From: Christopher Ashworth [mailto:CAshworth@cityofsydney.nsw.gov.au]
Sent: Wednesday, 17 June 2015 4:47 PM
To: Brendon Roberts
Cc: Amy Watson; Natasha Ridler
Subject: North West Plot, Darling Square, Darling Harbour (SSD 6013 MOD 1) – Response To Submissions

RE: NORTH WEST PLOT OF DARLING SQUARE, DARLING HARBOUR (SSD 6013 MOD 1) – RESPONSE TO SUBMISSIONS

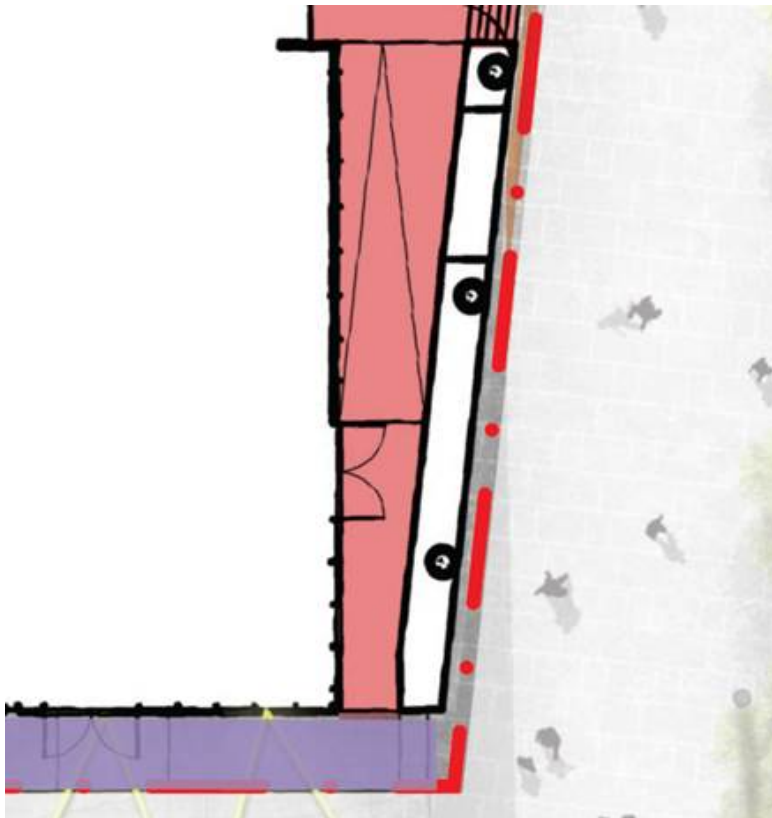
Treatment to south eastern corner

Additional information should be sought with regards to the proposed treatment of the area in-between the external columns at the south eastern corner (illustrated in white below). There may be an opportunity to incorporate landscaping or high quality finishes in this area appropriate to the location, being the building's principal frontage.
